TRAIL & SIDEWALK FEASIBILITY STUDY – PHASE 2

Madeline Avenue, From County Road 4009 (S
Williamson Boulevard) to County Road 483 (Clyde
Morris Boulevard)

City of Port Orange
FINAL Report, January 2019

To: Mr. Stephan Harris, Transportation Planner–Project Manager
From: Mr. Chris Walsh, P.E., Mr. Mikal Hale, P.E.
Subject: Madeline Ave Trail & Sidewalk - PH 2 – Response to Comments
Date: January 31, 2019

TYPICAL SECTION 01
MADELINE AVENUE
STA 100+40 TO STA 109+20

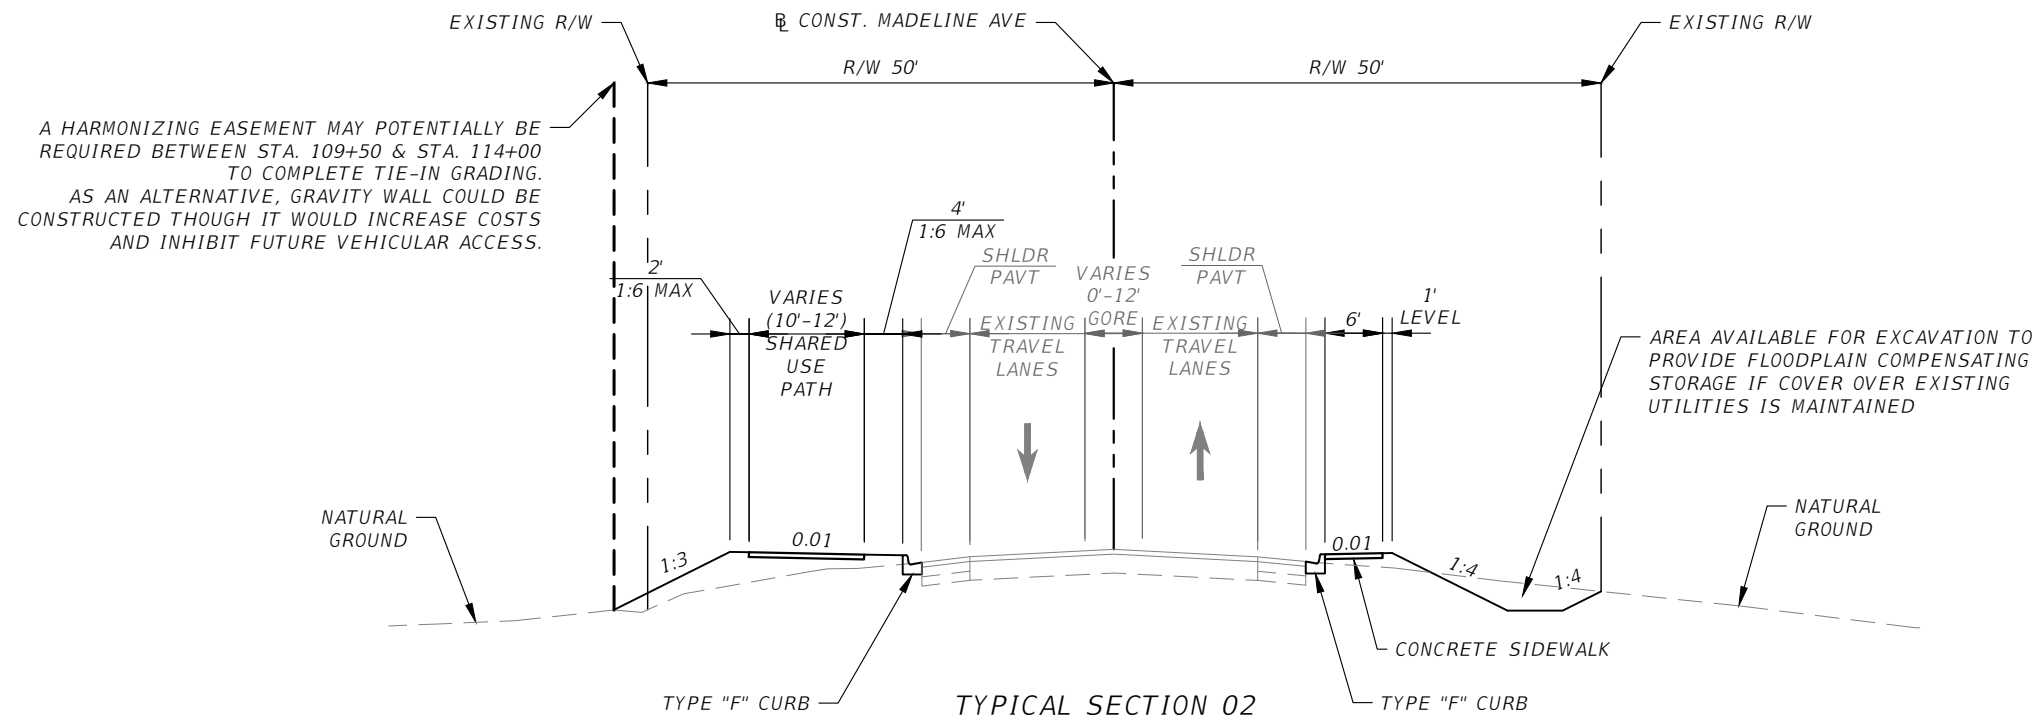
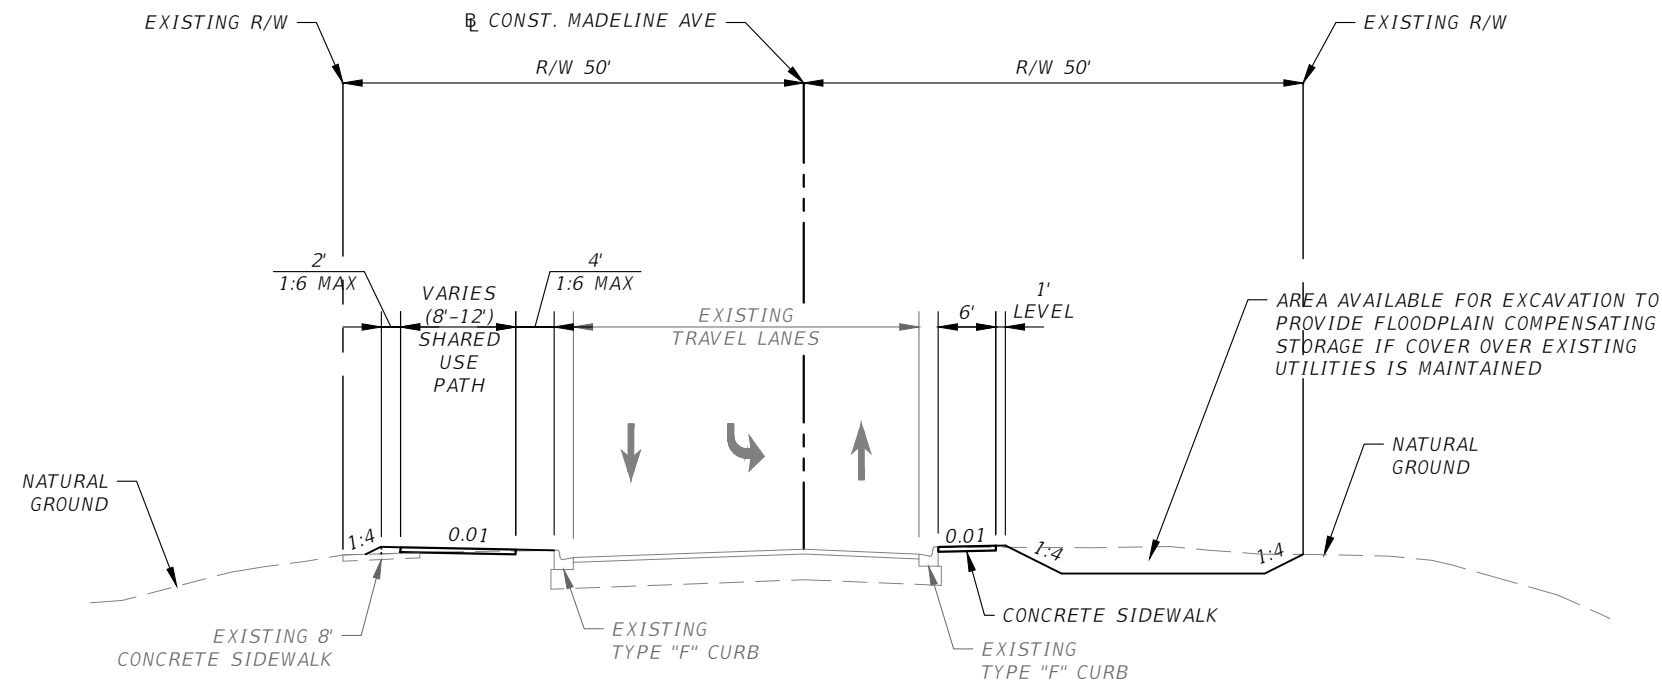
1. Typical Sections Sheets 1,2 - The typicals show floodplain compensation behind the sidewalk with a note stating if cover over existing utilities is maintained. Is there any concern about floodplain compensation if the utilities do not allow for these swales?

Response: The proposed swales will likely be only 1 – 2 feet in depth at maximum. Per email correspondence with Elizabeth O'Reilly on January 25th, 2019, the City Utilities Department is satisfied that there is sufficient cover over the 12" water main in both Phase 1 and Phase 2 of Madeline Avenue and that no modifications to the feasibility study is warranted.

REVISIONS		MADELINE AVENUE TRAIL & SIDEWALK PHASE 2			CONCEPT PLANS PHASE 2	SHEET NO. 4
DATE	DESCRIPTION	ROAD NO.	COUNTY	FINANCIAL PROJECT ID		
1/22/2019	REVISED PER CITY, FDOT AND R2CTPO COMMENTS	..	VOLUSIA	----

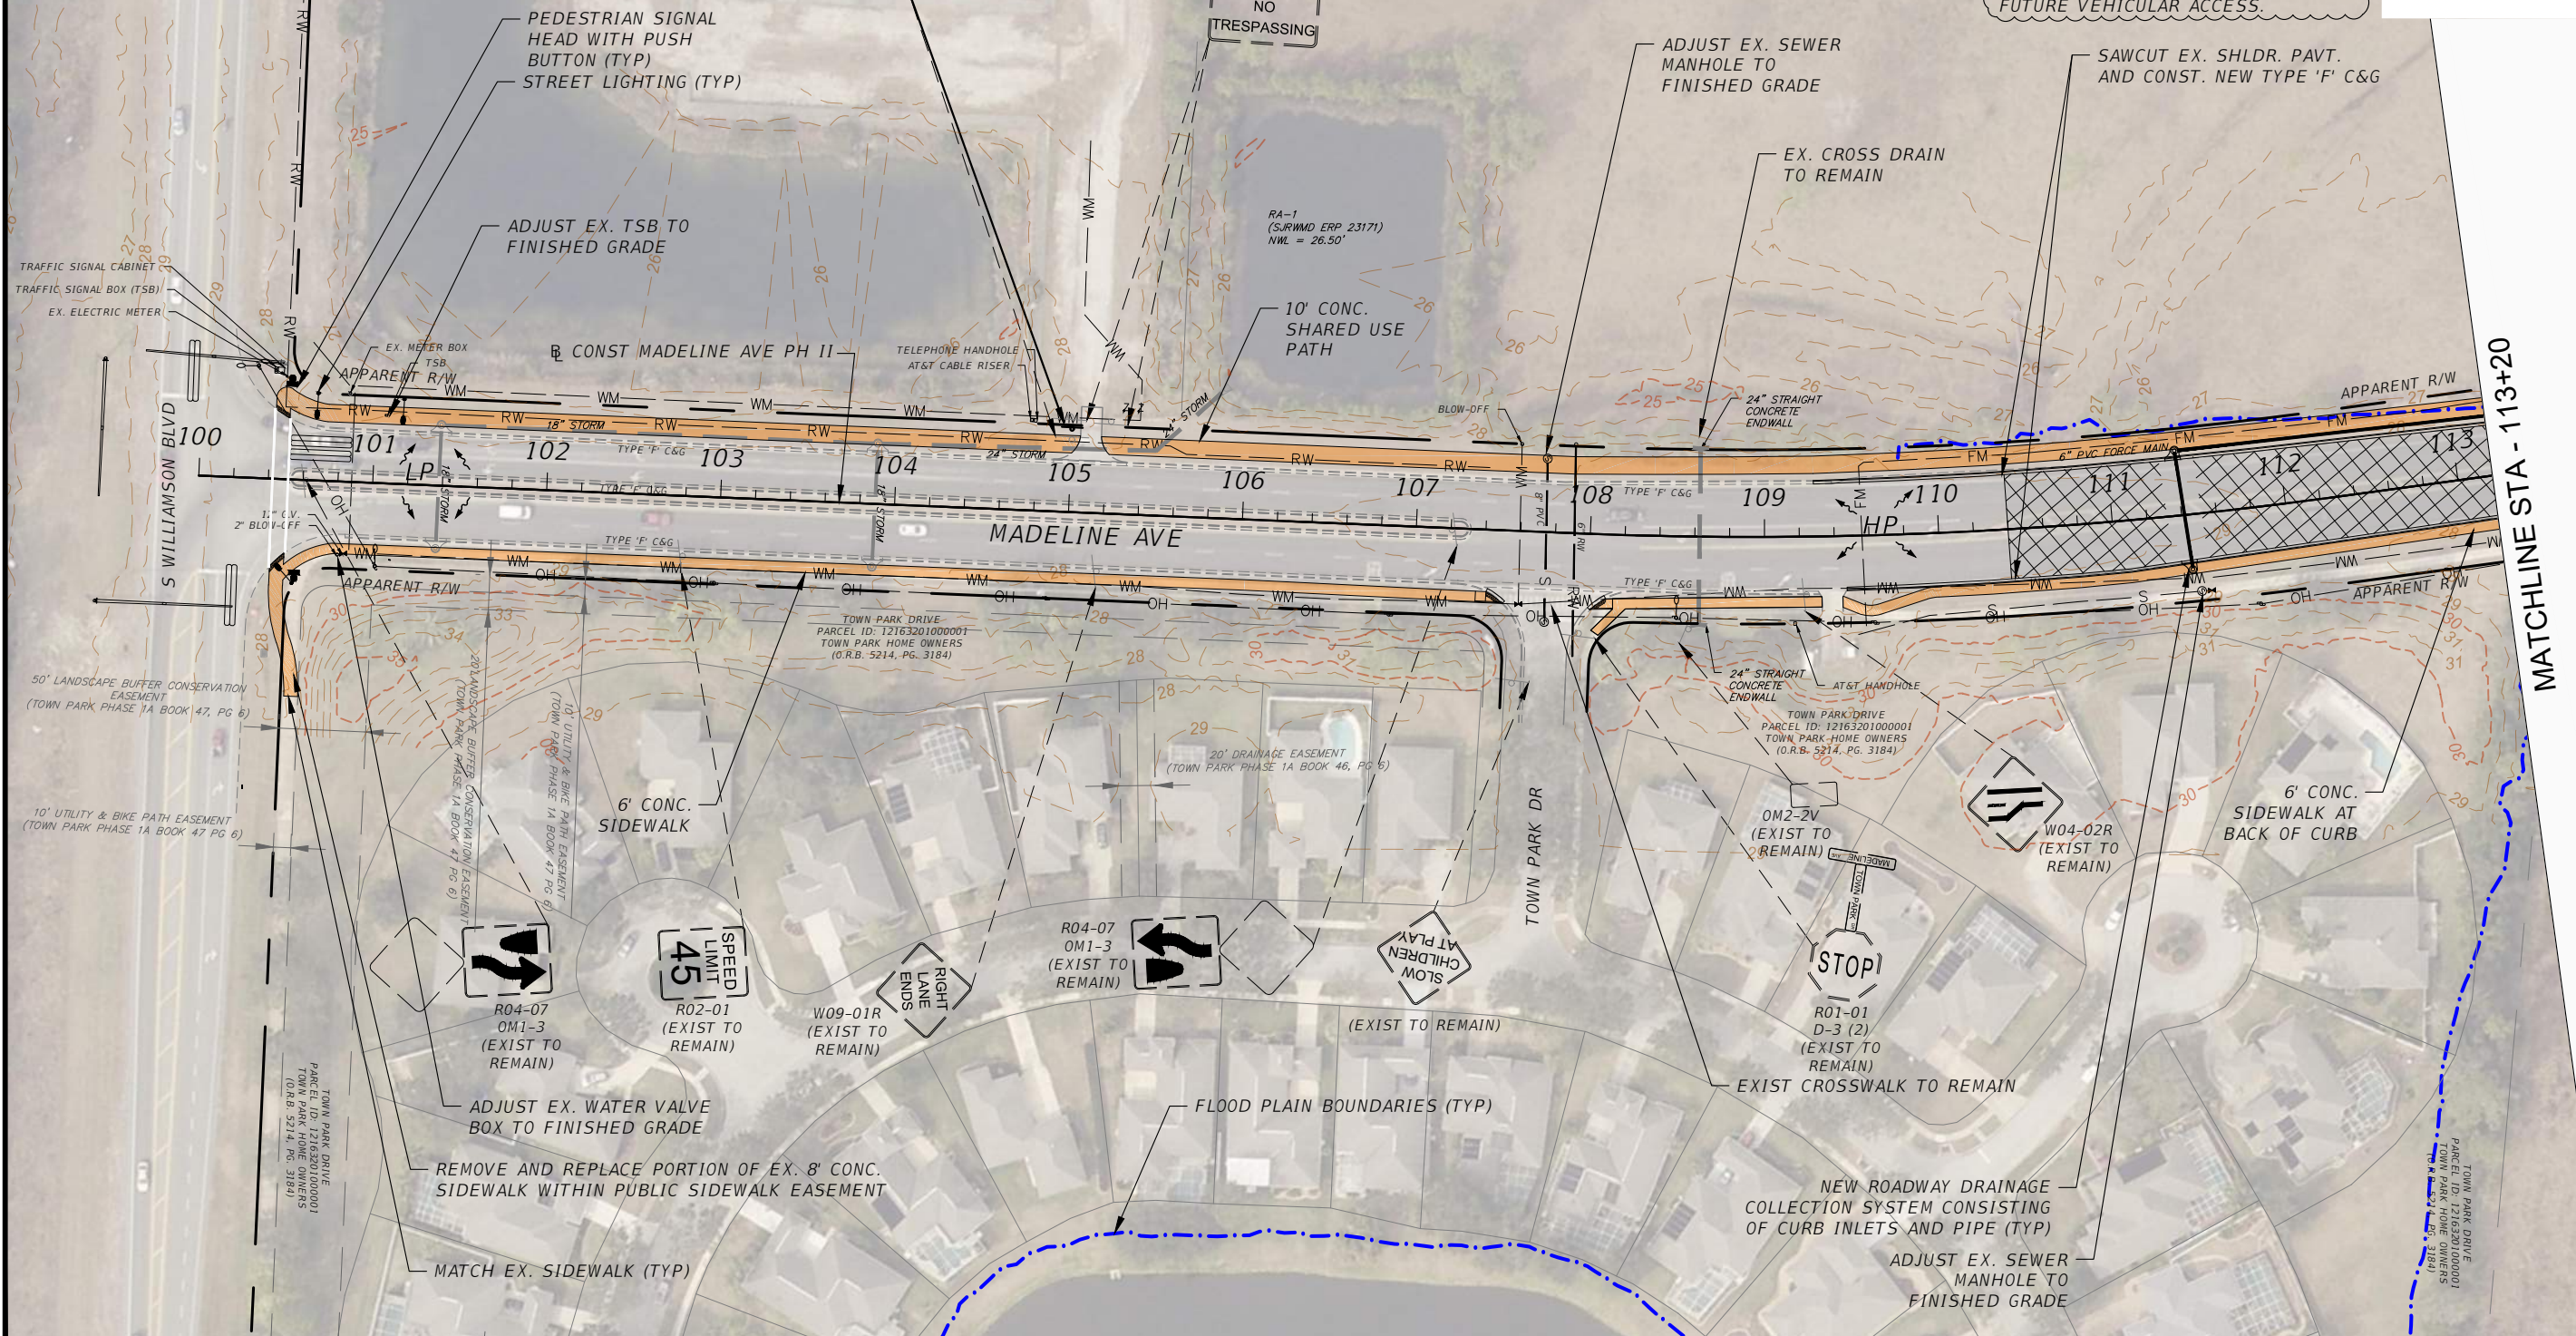
2. Sheet 4 Concepts - sidewalk outside apparent ROW: Recommend including documentation of the Public Sidewalk Easement in the SE quadrant within the study, as Page 7 references several record engineering documents.

Response: Please see revised Sheet 4 which now more clearly depicts the existing 10' Utility & Bike Path Easement that was dedicated to the City in the Plat of Town Park Phase 1A (MB 47, PGS 5-7), a copy of which has now been included in Appendix F.

SHEET NO.
5

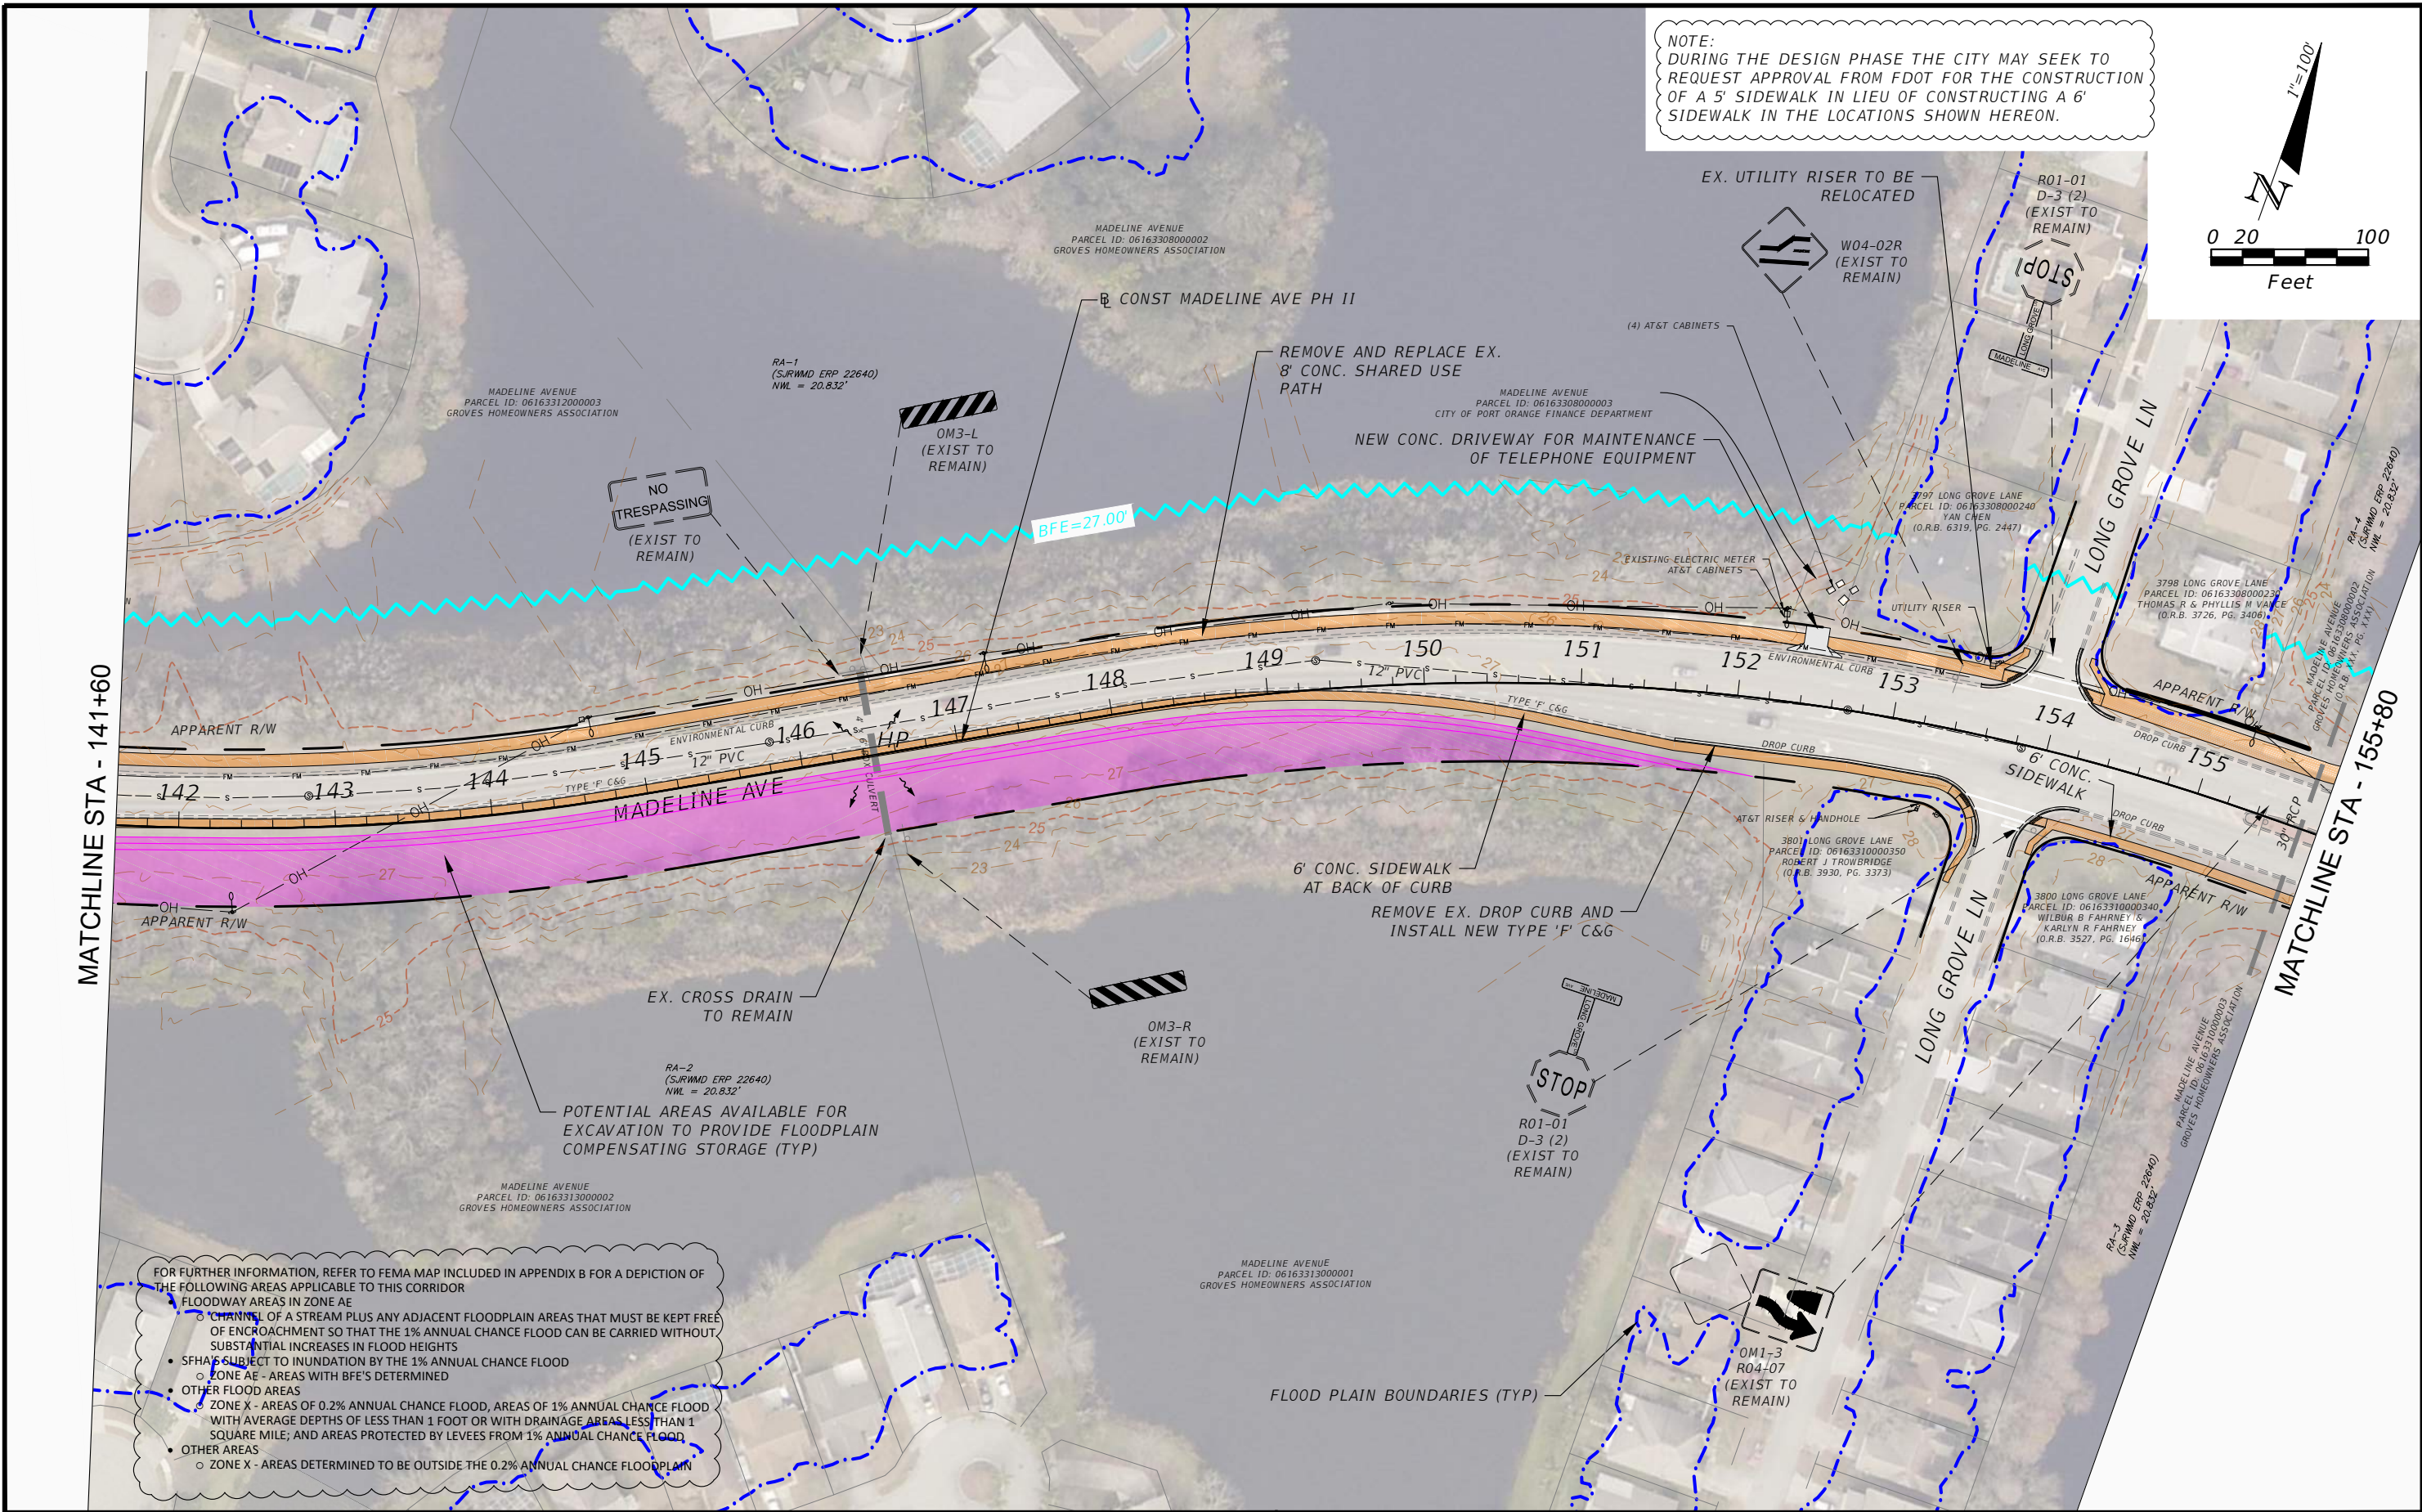
1. The original Feasibility Study application called for a minimum 5' sidewalk along the south side of Madeline Avenue and the draft Feasibility Study calls for a 6' sidewalk (Sheet 5, 6, 7, and 8). City request it is indicated in the Feasibility Study that the sidewalk along the south side of Madeline Avenue be between 5' and 6' wide or minimum of 5' to give flexibility on the sidewalk width during design. City may opt to build a 5' wide sidewalk to reduce construction and future maintenance cost.

2. The original Feasibility Study application was for a minimum 8' sidewalk/multi-purpose trail along the north side of Madeline Avenue and the draft Feasibility Study calls for sidewalk/multi-purpose trail width between 8' to 12' (Sheet 5, 6, 7, and 8). City request it is indicated in the Feasibility Study that the sidewalk/multi-purpose trail along the north side of Madeline Avenue be a minimum of 8' wide to give flexibility on the width during design. City may opt to build an 8' wide sidewalk/multi-purpose trail to reduce construction and future maintenance cost.

Response: Per discussion on the January 16, 2019 phone conference, the study will remain showing a 6' sidewalk per current FDOT design guidelines, despite the fact that in the design phase, the City may revisit this subject to see if FDOT would approve the construction of a 5' sidewalk instead. A note to this effect has been added to Section 4 Trail and Sidewalk Concept Plan.

Response: Per FDM 224.4, shared use paths have a preferred width of 12-feet, a minimum width of 10-feet and may contain short segments of 8-feet in constrained conditions. Per discussion on the January 16, 2019 phone conference, the study will remain showing 10' and 12' shared use path where feasible per current FDOT design guidelines, as requested by Stephen Harris at the July 18, 2019 scoping meeting.
